**DETERMINATION OF NO REGULATED ACTIVITY OR, IN THE
ALTERNATIVE, REQUEST TO CONDUCT REGULATED
ACTIVITIES ASSOCIATED WITH PROPOSED PICKLEBALL
COURTS LOCATED AT 51 DANIELS AVENUE**

MAY 1, 2025

Re: Request For Determination Of No Regulated Activities Or, In The Alternative,
Request For Approval To Conduct Regulated Activities Associated With
Proposed Pickleball Courts; 51 Daniels Avenue, Waterford CT

**LEARN Response to Environmental Planner Comments
New School – 51 Daniels Avenue**

CS100

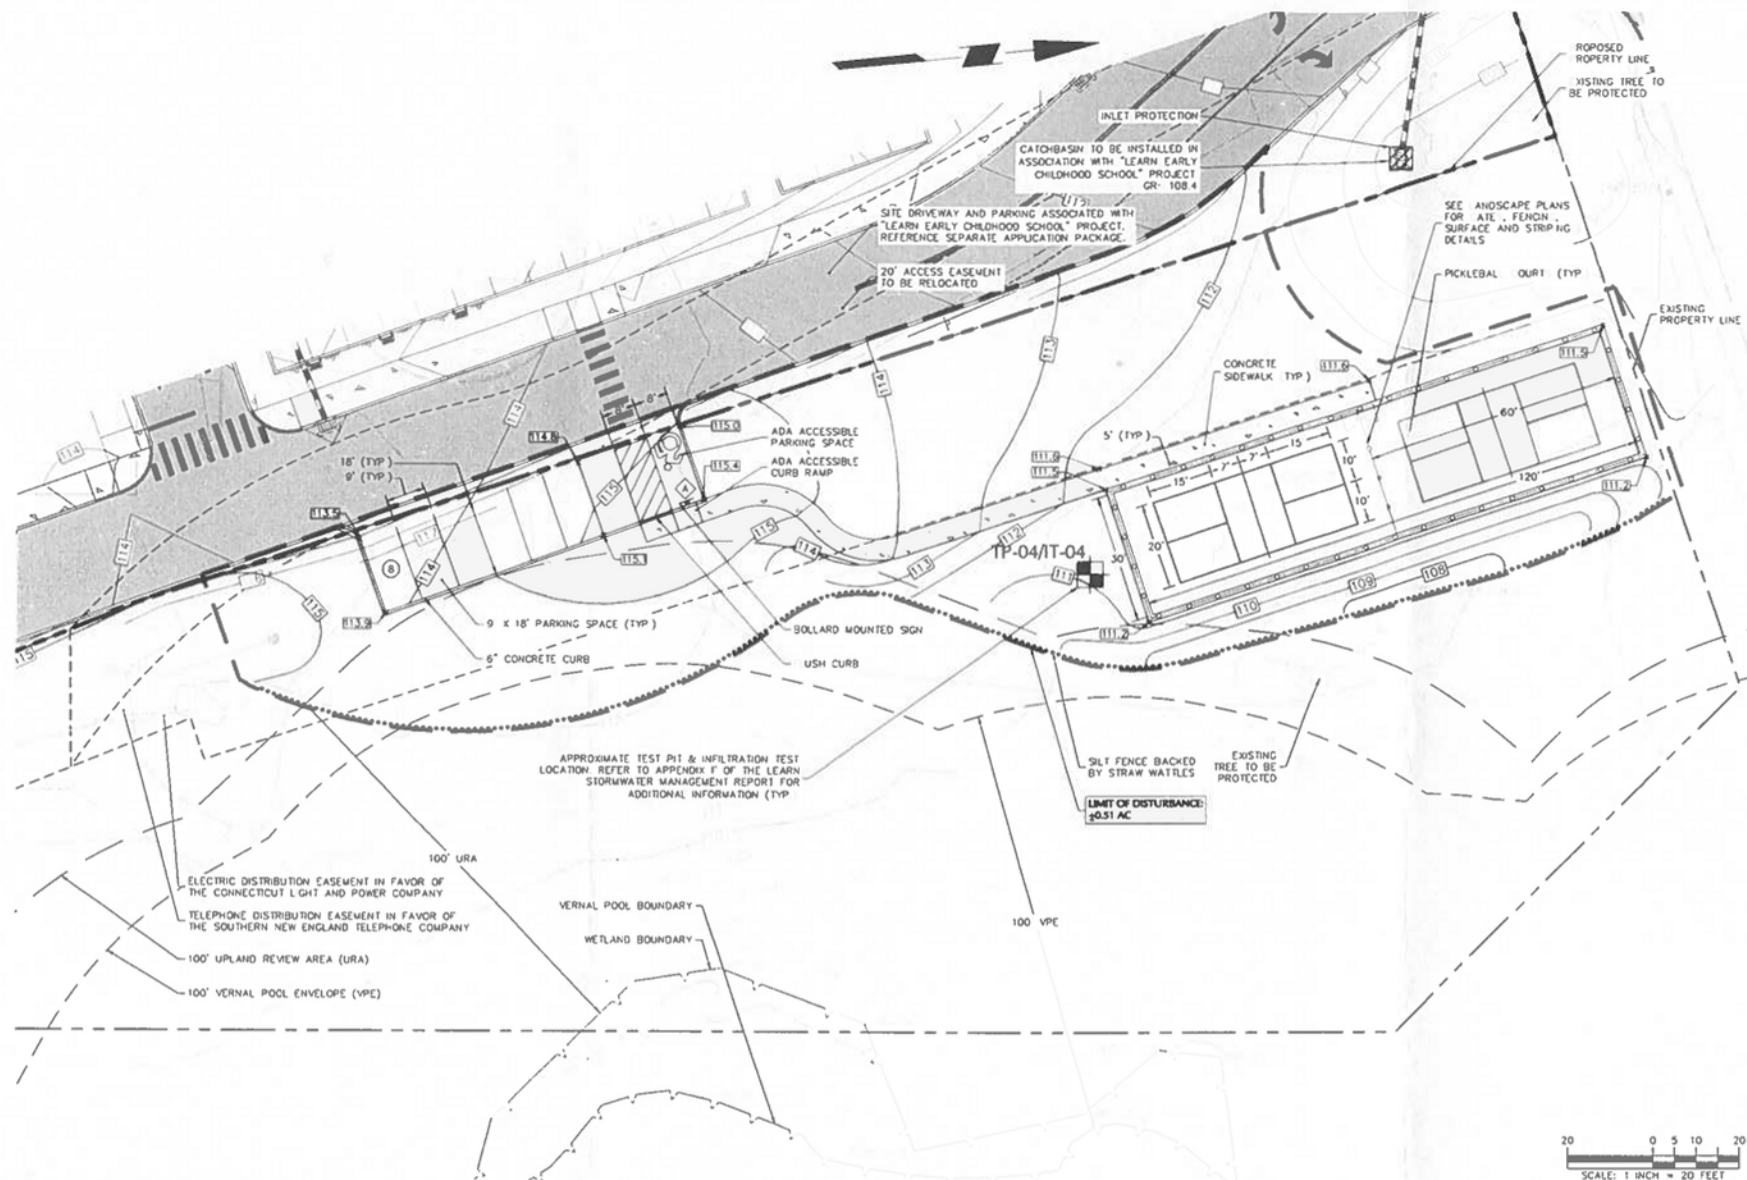
16. *If the pickle ball courts are remaining as part of the overall project site plan application, the limits of disturbance and extent of site grading and construction activity for this amenity must be shown on the overall site plan sheets and the grading and S&E control plan sheets. This is located within the upland review area of an inland wetland that is partially on the subject property and is an off-site vernal pool breeding area.*

RESPONSE: The pickleball court design has been submitted as a separate application package because the pickleball courts will be located on the portion of the site to be retained by the Town and will be owned and operated by the Town. A separate wetland assessment has been provided as a part of the pickleball court application.
